NUREG-0130

**for Facility License Amendment
for Extension of Operation
With Once-through Cooling**

INDIAN POINT UNIT NO. 2

Docket No. 50-247

Fig. 3-1. Curves for relative yield versus time. The three curves are for cessation of once-through cooling at Indian Point Unit No. 2 on May 1, 1979 (solid line) and on May 1, 1981 (dashed line) and for the base design of once-through cooling for 35 years at both Unit Nos. 2 and 3 (dotted line).

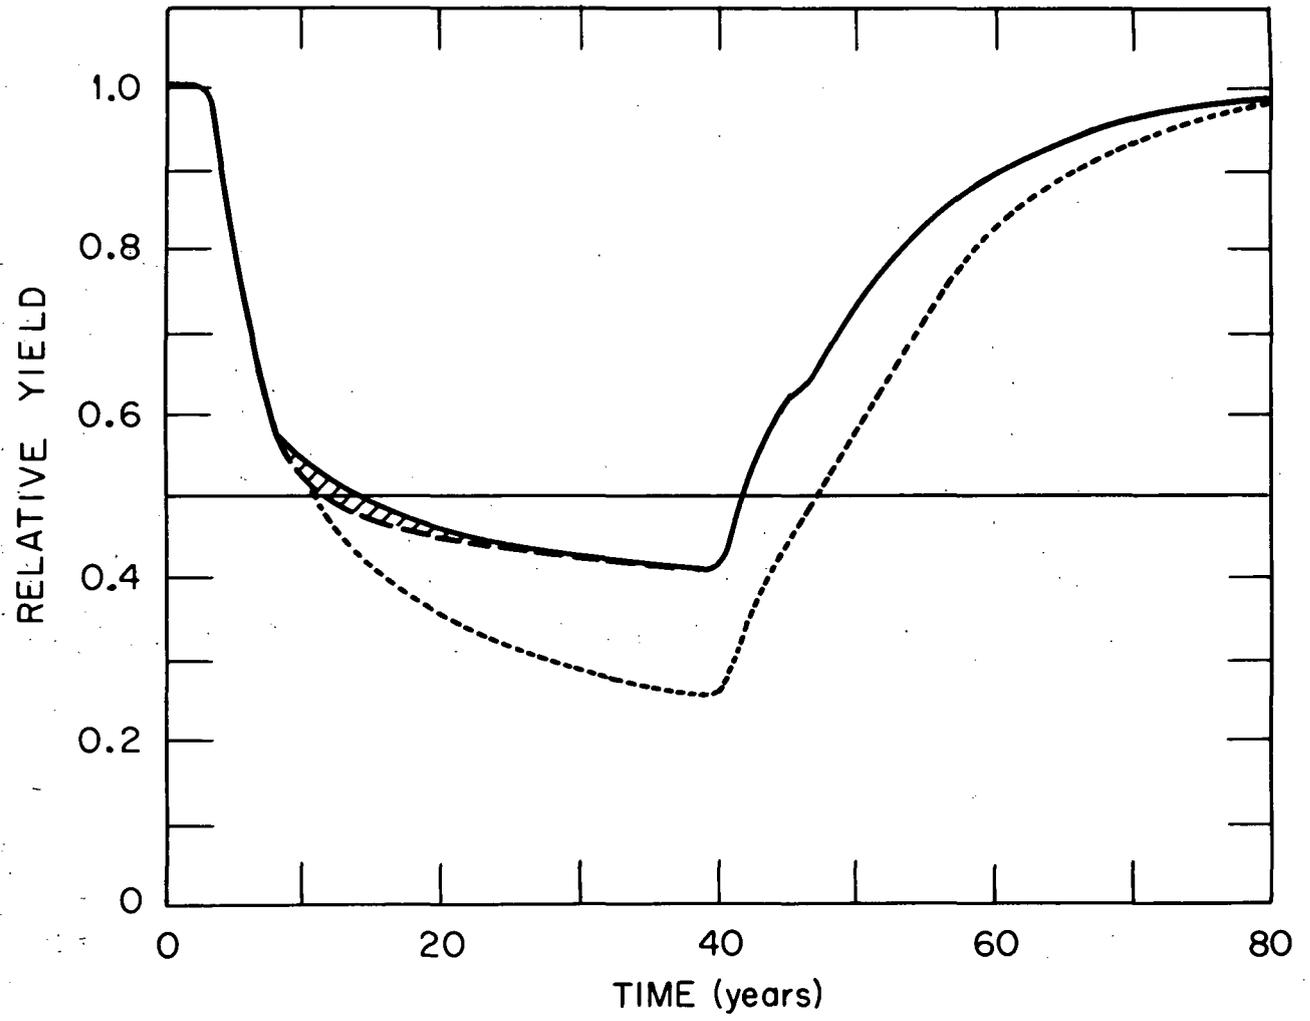
The West Branch Conservation Association comments concerning Fig. 3-1 of the present RES (i.e., Relative Yield versus Years) "that even after cessation of once-through cooling the decline will continue." Such a time delay of three years between cessation of the power plant impact and an increase in yield to the fishery is exactly what would be expected (in fact, required) of any such life-cycle population model. Note that there is a similar three-year time delay between the initiation of power plant impact at year 0 and decrease in yield to the fishery. Both of these time delays occur because the power plants effect the zero age class, whereas fish are not recruited into the fishery until they are three-year olds. These time delays do not, in and of themselves, have any bearing on the question of irreversibility.

Fig. 3.2 General ecological survey and special studies.

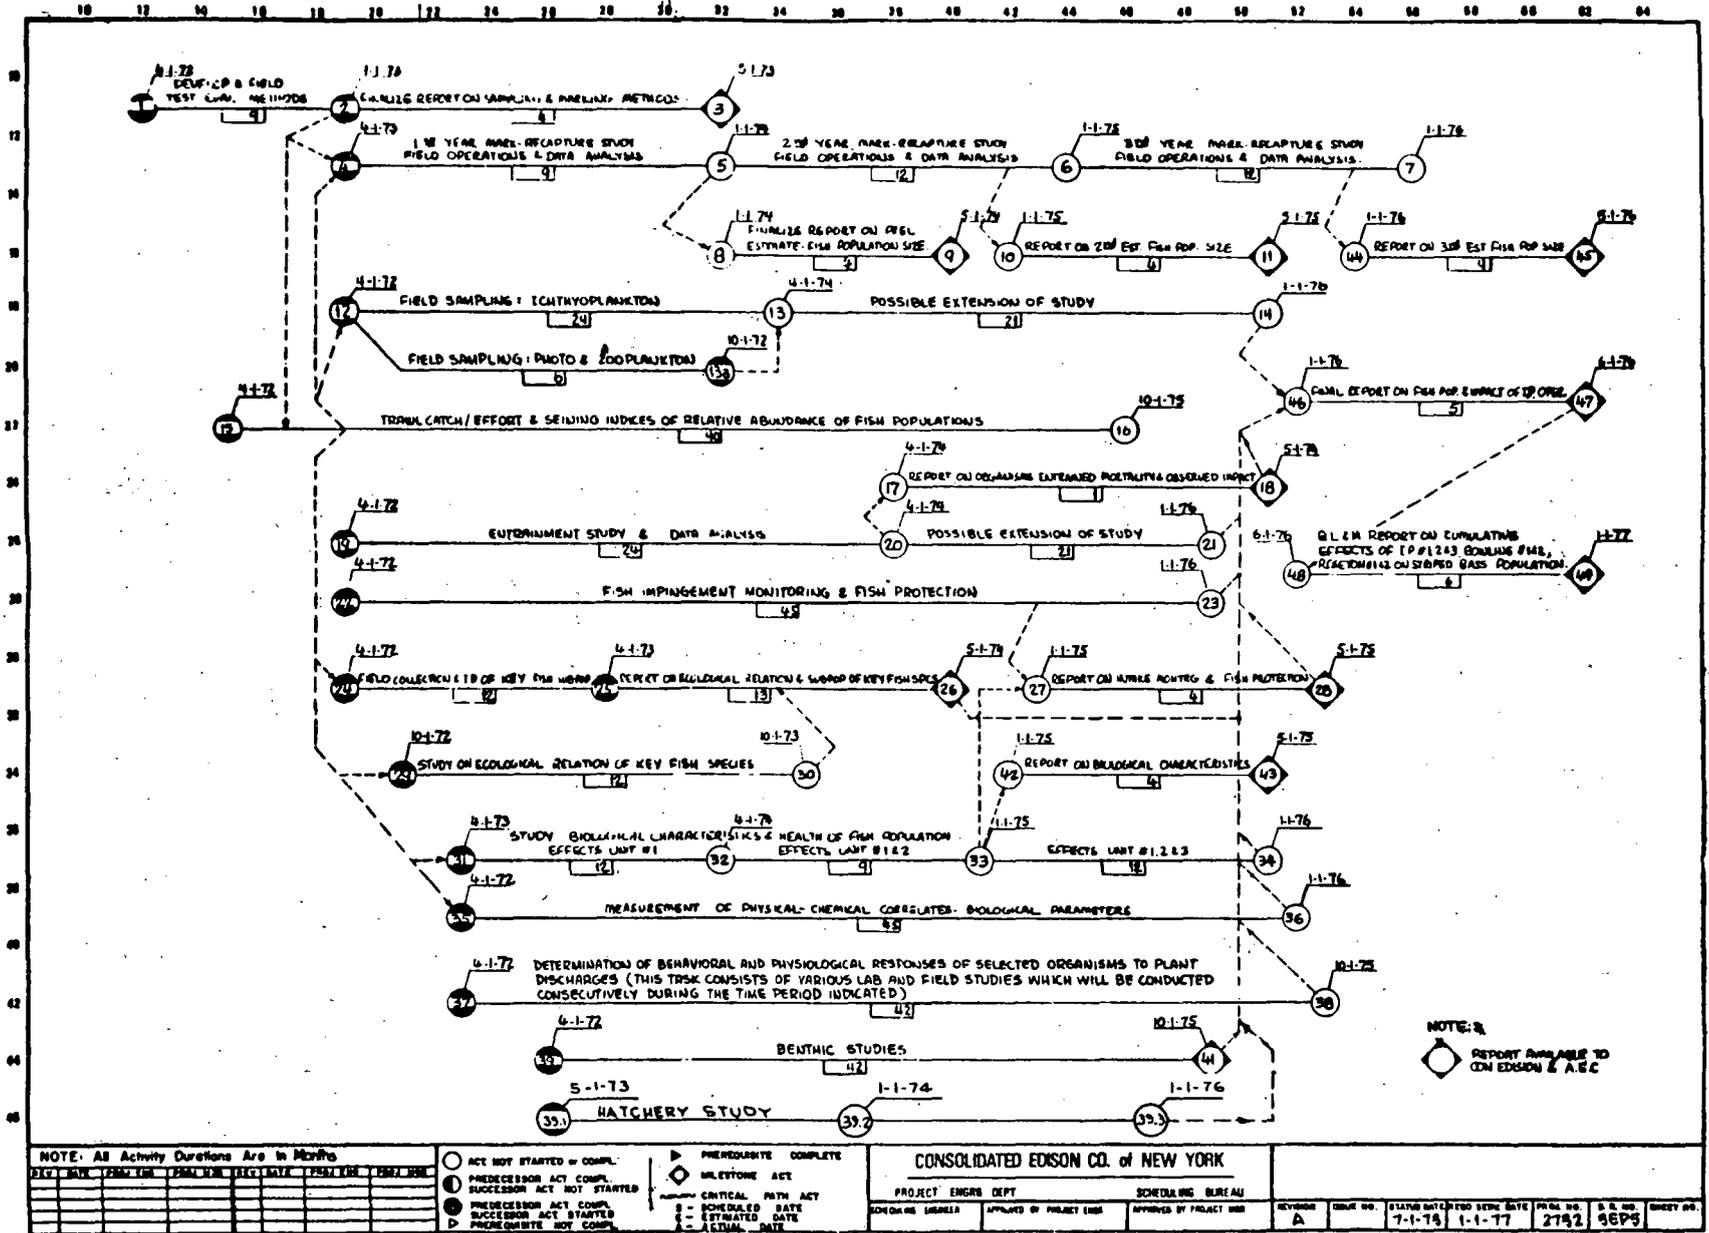
Figure 3.2 indicates that assessment of effects of Indian Point Unit 3 will be completed by January 1977. Because of construction delays, Unit 3 did not begin operational tests until May, 1976, and hence its effects will not be assessable until after 1977. However, predictions of plant impact based on data collected at Unit 2 will be made and presented in the January, 1977 report.
